GROUP TRA	MODEL 2017-2018MY Soul (PS) 1.6T Forte (YDm) 1.6T 2016-2018MY Optima (JFa) 1.6T
	NUMBER 078	DATE June 2019

## TECHNICAL SERVICE BULLETIN

**SUBJECT: TRANSMISSION LOGIC IMPROVEMENT**

This bulletin provides the procedure to optimize the logic of the Transmission Control Unit (TCU) on 2017-2018MY Soul (PS) and Forte (YDm) and 2016-2018MY Optima (JFa) vehicles equipped with 1.6T GDI that have one of the following three components replaced:

### DCT Assembly / Double Clutch Set Replacement Flow Chart

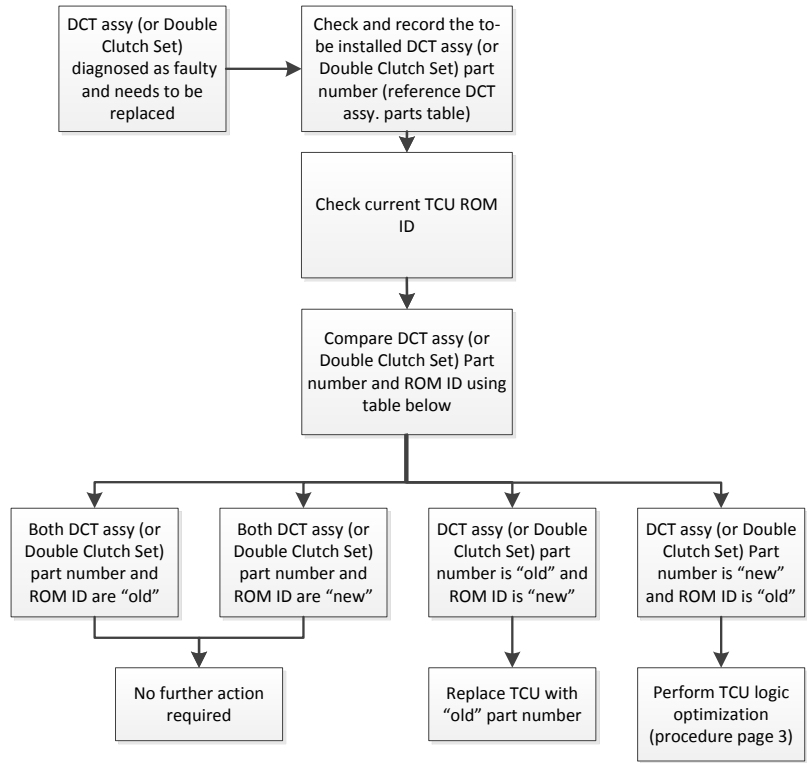
The friction material of the double clutch set has been changed and a TCU logic optimization must be performed in order to prevent initial shift shock. To prevent this concern, apply the optimized logic to the TCU using the KDS ECU Upgrade function as described in this bulletin. For confirmation that the latest reflash has been applied to a vehicle you are working on, verify the ROM ID using the table on page 3 of this bulletin.

Model	ENG	TM	OLD		NEW	
			TCU ROM ID	<u>Dbl. Clutch Set (F833DS)</u>	TCU ROM ID	<u>Dbl. Clutch Set (F850)</u>
JFa	1.6T	7DCT	DJF0T16NS0 DJF0T16NS1 DJF0T16NS2 DJF0T16NS3 DJF0T16NS4 DJF0T16NS5	41200 2D101	DJF0T16NS9	41200 2D220
PS			DPS0T16NS0 DPS0T16NS1		DPS0T16NS4	
YDm			DYD0T16NS0 DYD0T16NS1 DYD0T16NS2		DYD0T16NS5	
Model	ENG	TM	OLD		NEW	
			TCU ROM ID	<u>DCT Assembly (F833DS)</u>	TCU ROM ID	<u>DCT Assembly (F850)</u>
JFa	1.6T	7DCT	DJF0T16NS0 DJF0T16NS1 DJF0T16NS2 DJF0T16NS3 DJF0T16NS4 DJF0T16NS5	43000 2D081	DJF0T16NS9	43000 2D086
PS			DPS0T16NS0 DPS0T16NS1	43000 2D190	DPS0T16NS4	43000 2D195
YDm			DYD0T16NS0 DYD0T16NS1 DYD0T16NS2	43000 2D101	DYD0T16NS5	43000 2D106
